APPLICATION FOR PERMISSION
A/YL-TYST/1146 UNDER SECTION 16 OF
THE TOWN PLANNING ORDINANCE
(CAP.131)

Proposed Service Reservoirs

**Agreement No. CE 71/2020 (CE)
Hung Shui Kiu/Ha Tsuen New
Development Area Package B
Works for Second Phase
Development – Design and
Construction**

**Planning Submission of Service
Reservoirs**

Drawing No.	Scale	Author	Checked	Approved
FIGURE 5a	1:1000 @ A1	EF	EF	A

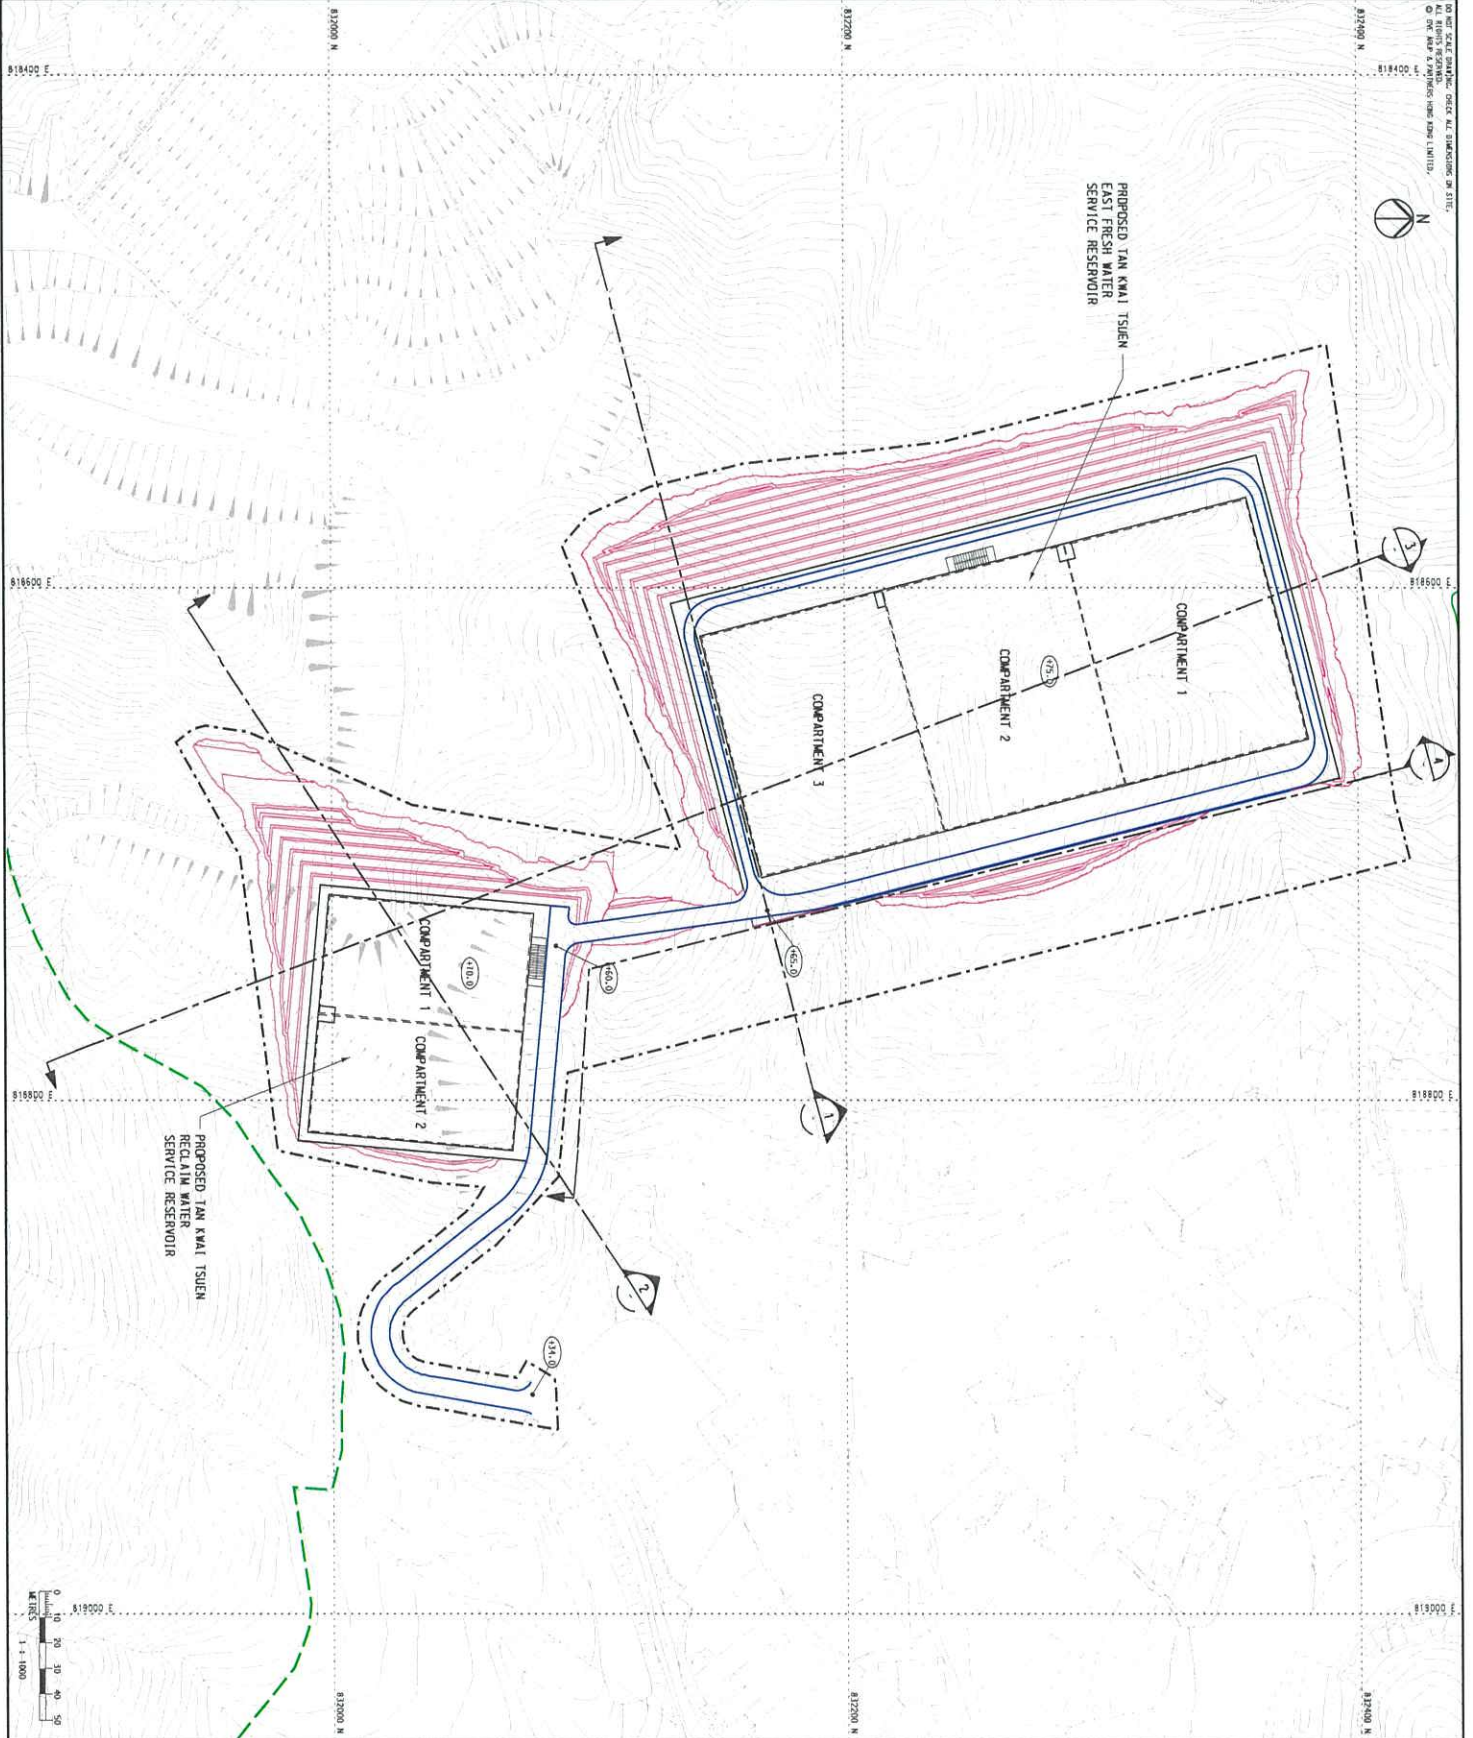
- 1) 請提供于圖紙 (編號: FIGURE 5a) 上注示的Section 4 的圖紙供參考。
- 2) 公示文件上的視覺點 (Viewpoint) 過於片面, 此配水庫勢必影響唐人新村西向的景觀, 且破壞當地原住民喪葬位置。
- 3) 修建大型配水庫會影響當地環境。

Figure 1 – Application Site of the Proposed Service Reservoirs and the Concerned Two Private Lots

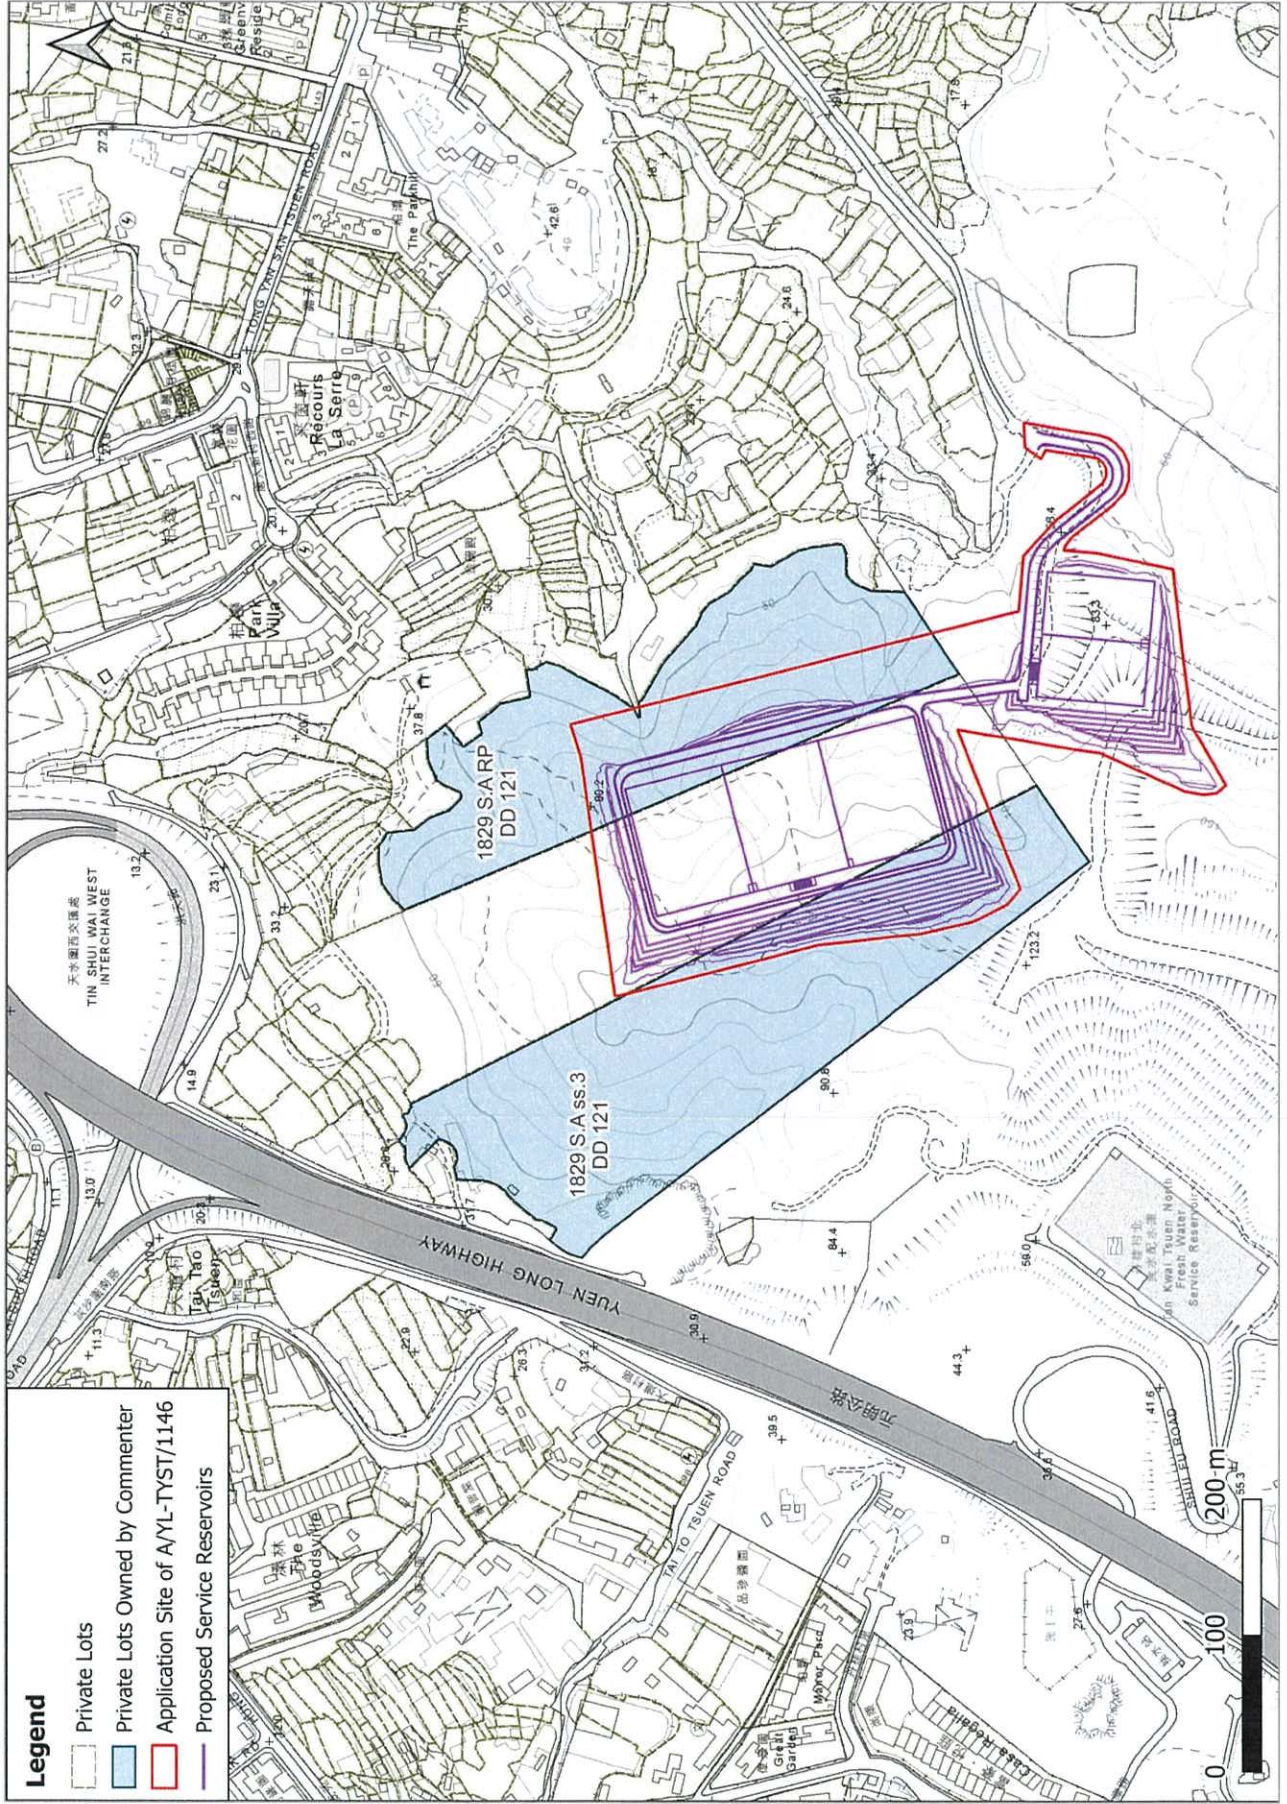
- (1) The application, if approved, will require resumption of major portions of the 2 mentioned private lots (i.e. Lot A and Lot B). As illustrated in the enclosed **Figure 1**, more than one-third of Lot A and about 20% of Lot B will be resumed for the subject proposal.
- (2) Lot A would be bisected into 2 isolated portions and leaving the northern portion inaccessible. We therefore earnestly request Town Planning Board, in giving its approval, to impose conditions requiring CEDD to provide access (and/ or maintain existing access) of the northern portion of Lot A through the southern portion.
- (3) In view of large-scale slope cutting, we would like to request further information (including detailed drawings) of the proposed service reservoirs for our assessment of the impacts thereby to the geotechnical stability of our Lot A and Lot B.
